**JOINT ARCHITECTURAL BOARD/PLAN COMMISSION AGENDA
MONDAY, FEBRUARY 16, 2015
7:00 PM
BOARD ROOM, MUNICIPAL BUILDING, 210 COTTONWOOD AVE.**

**VILLAGE OF HARTLAND
JOINT ARCHITECTURAL BOARD/PLAN COMMISSION MINUTES
MONDAY, JANUARY 19, 2015
7:00 PM
BOARD ROOM, MUNICIPAL BUILDING, 210 COTTONWOOD AVE.**

TO: Plan Commission
FROM: David E. Cox, Village Administrator
DATE: February 12, 2015
SUBJECT: Four Winds West

TO: Plan Commission
FROM: David E. Cox, Village Administrator
DATE: February 13, 2015
SUBJECT: Hartland Service Site Enhancements

Drawing No. 1815-grb/deb
Sheet 1 of 3 Sheets

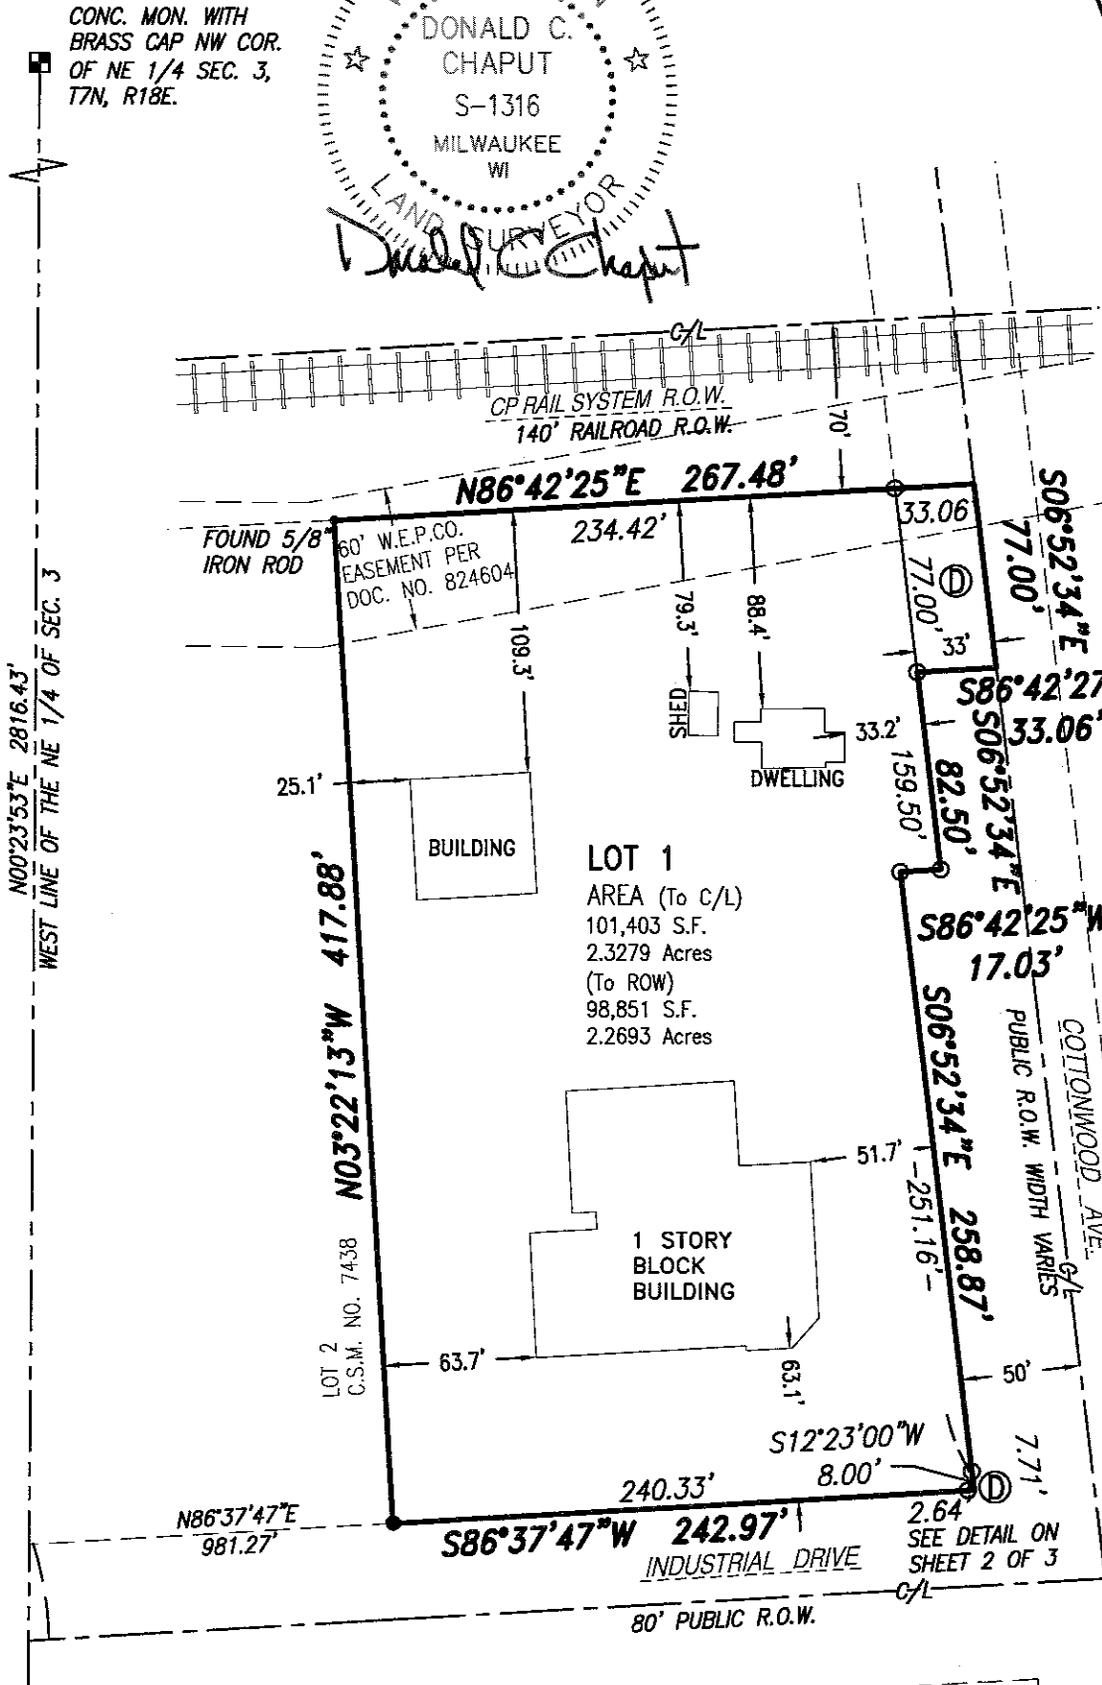
12. Per Division 4, Sec. 50-136 (13): The centerline of Industrial Drive must be shown as being parallel to the south line of Lot 1.
13. Per Division 4, Sec. 50-137: The Plan Commission may require additional information.

18. Add Consent of Mortgagee at the Certificate page.
19. Change the date on the Certificate page from 2014 to 2015.

SANCTUARY OF HARTLAND

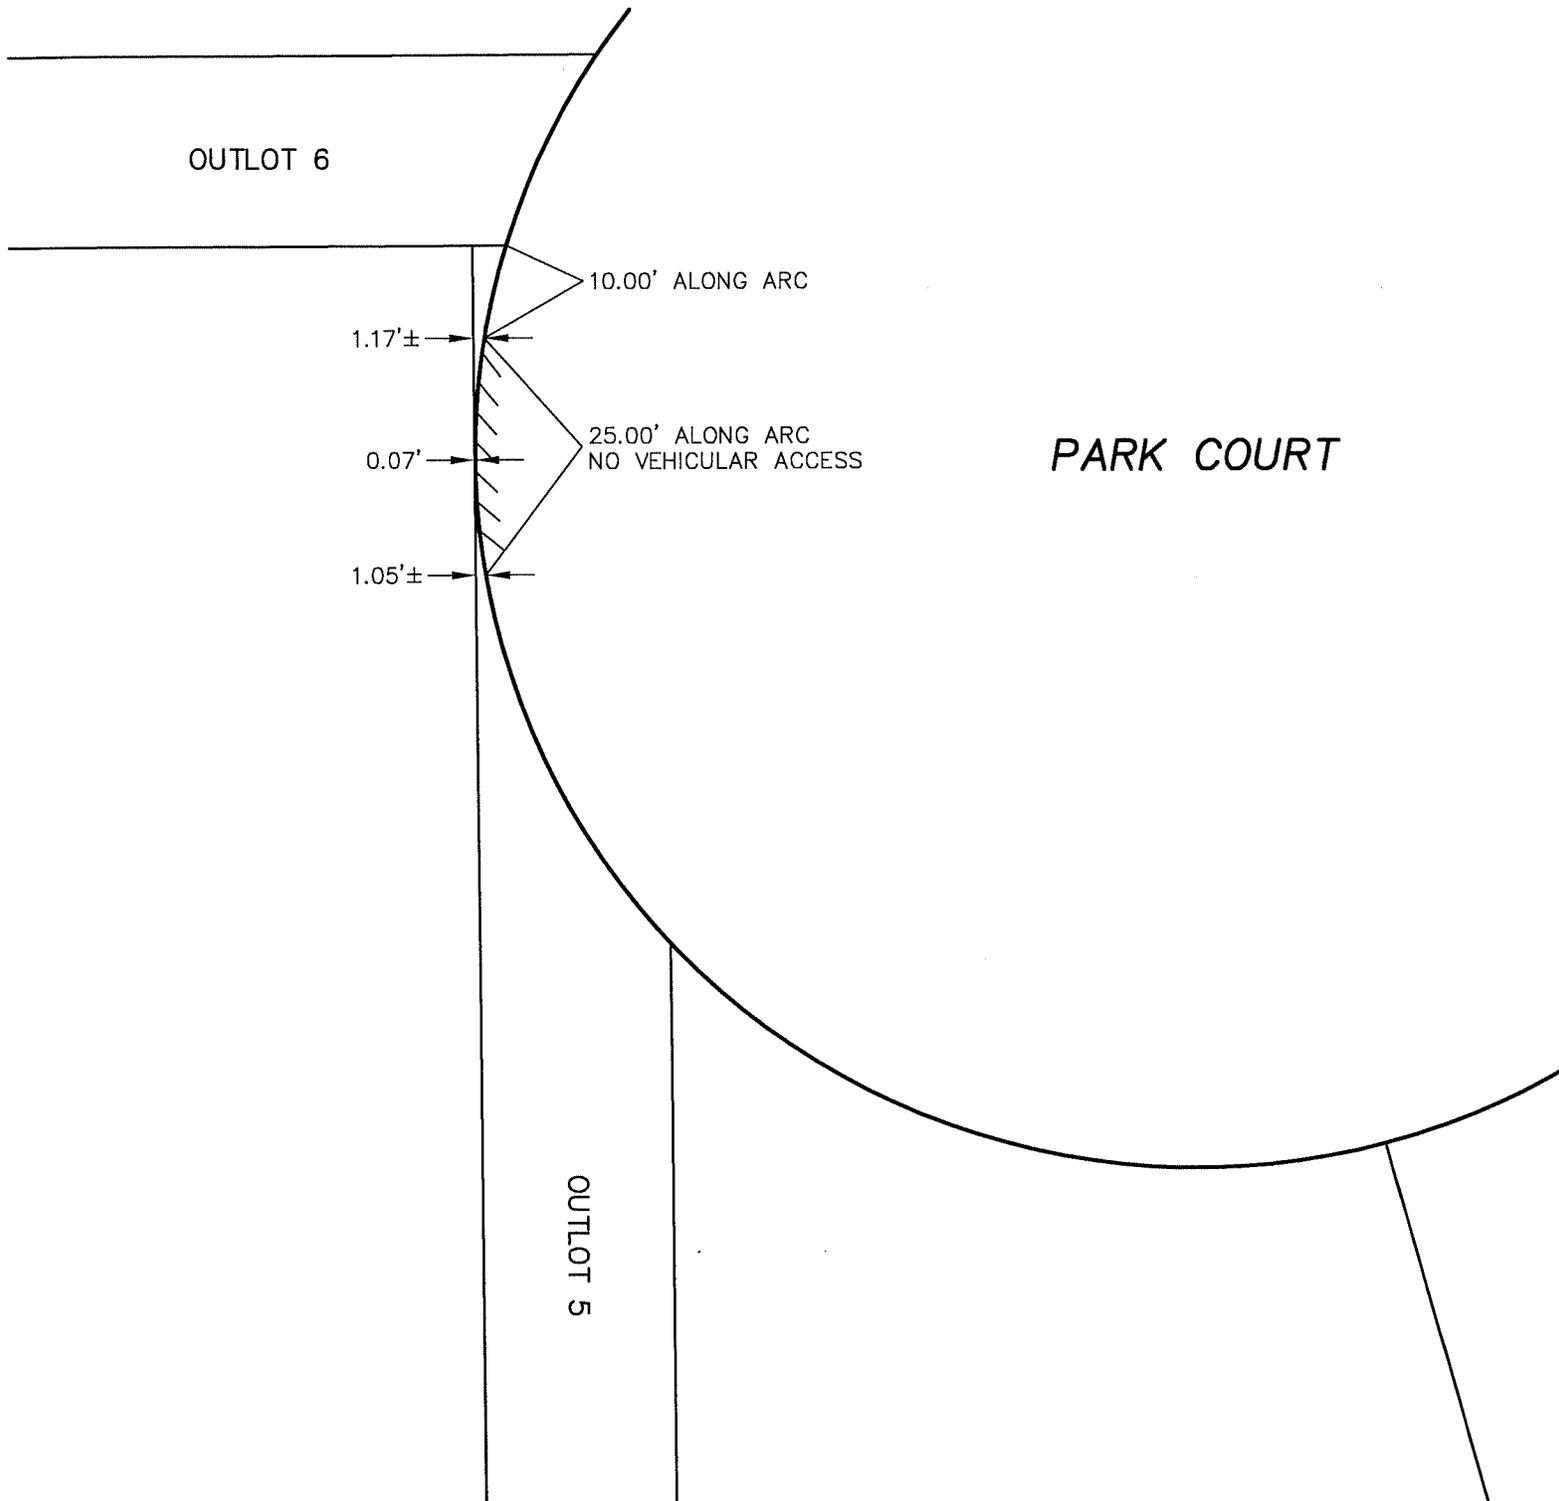
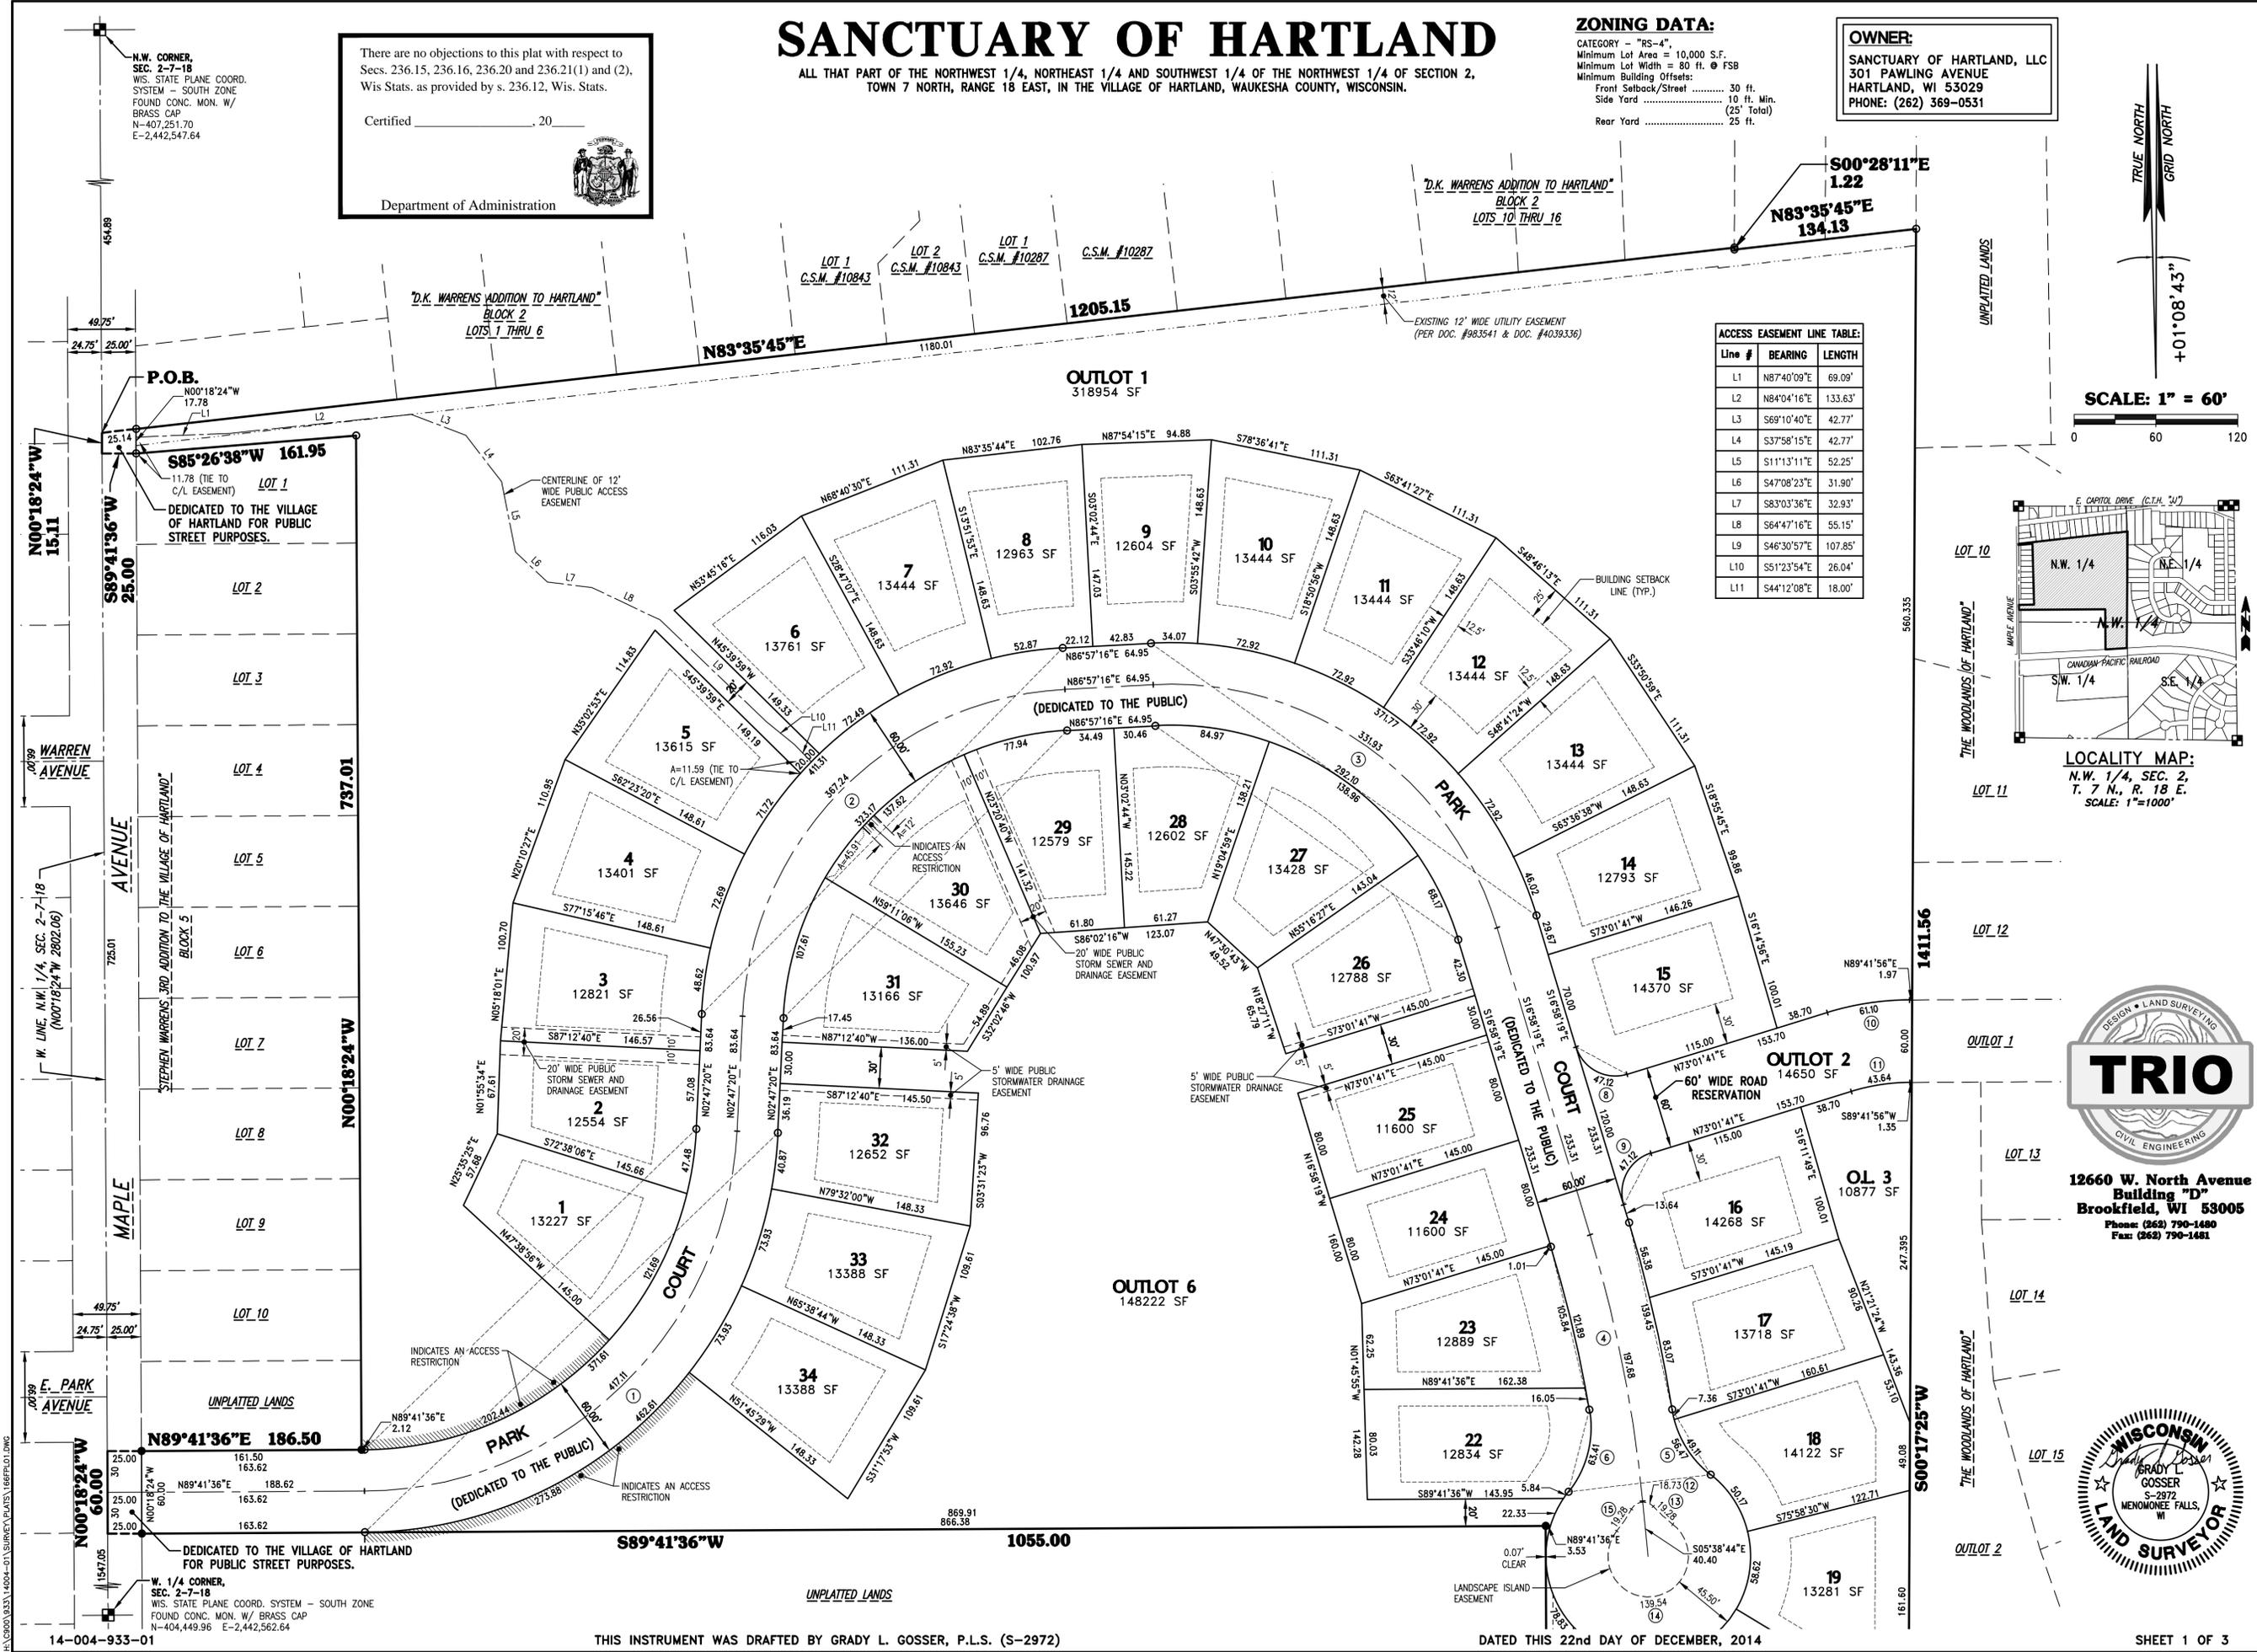
1. The word "assessments" shall be replaced with the word "charges" in the 8th note on sheet 2 of 3.
2. Utility easement language is noted on sheet 3 of 3. However, there are no associated easements on the face of the plat. Please identify the utility easement location on the face of the plat or remove the note, if there are no easements within the plat boundaries.

3. Per Sec. 50-92 (9): The Village of Hartland wants Outlot 2 to be transferred to the Village of Hartland
4. Per Sec. 50-136 (2): The Village of Hartland does not desire to have a blanket easement (upon, across within and beneath the surface of each lot) as indicated in the Utility Easement Provisions on Sheet 3 of 3 of the plat. Pursuant to Sec. 50-66 (4), utility easements are to be placed along rear or side lot lines. The suggested width of the utility easements should be 12.00 feet.
